APPLICATION FOR APPROVAL TO USE AN EXISTING ON-SITE WASTEWATER TREATMENT & DISPOSAL SYSTEM
MECKLENBURG COUNTY - GROUNDWATER & WASTEWATER SERVICES
700 N. Tryon St., Suite 211 Charlotte, NC 28202
Phone: (704) 336-5103 Fax: (704) 336-6894

Residential Subsurface Wastewater Treatment and Disposal System Design

Lot 92 – Stonebridge at Mint Hill
8042 Talcott Drive
Mint Hill, North Carolina

GWS Septic System Design Review

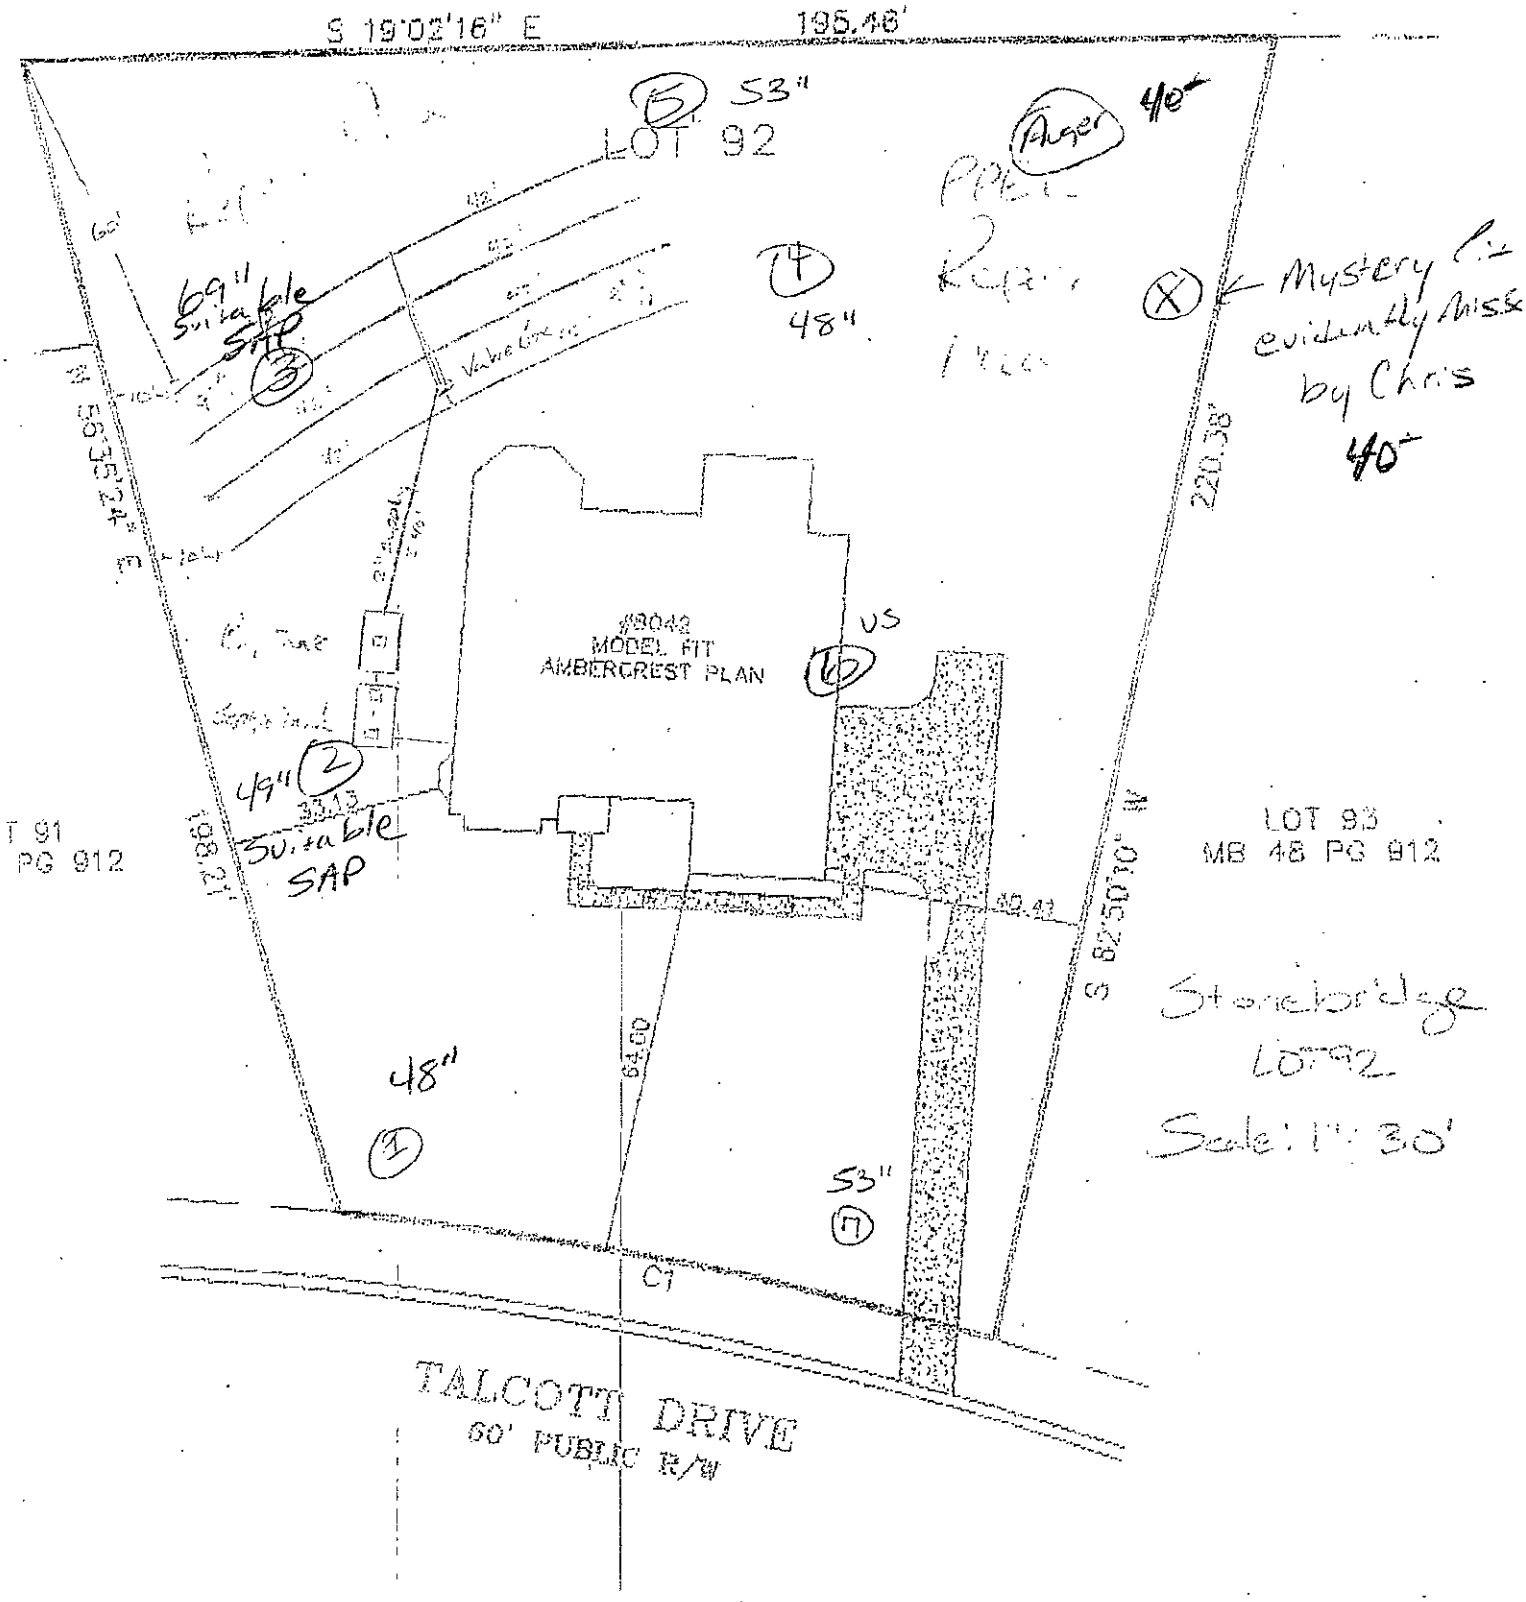
Thomason, Trevor wrote:
> Larry,
>
> The design calculations look ok for this site. I do have a few
> questions regarding the soil for lot #92.
>
> 1. Where are the pit locations (2) that you sent out for soil particle
> analysis? Please indicate these on your site layout sheet.
> 2. Was the soil evaluated in the right rear corner of the lot? Chris's
> report from 12/6/07 dos not indicate any borings or pits were evaluated
> in this area (proposed repair).
> 3. If any of the pits evaluated on 12/6/07 are located in the initial
> or repair area please show them on your site layout sheet.
>
> I will hold this proposal as pending until the above questions are
> resolved.
>
> Thanks,
> Trevor
>
> —Original Message—
> From: Larry Thompson [mailto:lthompson@thecatenagroup.com]
> Sent: Thursday, December 27, 2007 9:07 PM
> To: Thomason, Trevor

I revisited Lot 92 over the weekend and have attached my original layout with the actual pit locations overlain on the drawing. I confirmed that the saprolite samples were taken from Pits 2 and 3 vs. 1 and 3 as stated in my original response. Chris asked that we sample those pits and I thought that he would have made a note on his soil work stating such.

I also located one of our original borings and have noted it on the layout as well. That particular boring was 0-5" sandy loam, 5-48"+ clay.

The mystery pit is also noted. I left the lot before Chris was finished with his portion of the evaluation but I can tell you that this pit has
40+ inches of suitable soil.

If I need to prepare anything more formal, please let me know.
Otherwise, I think David can confirm the pit locations that I have shown on the layout.
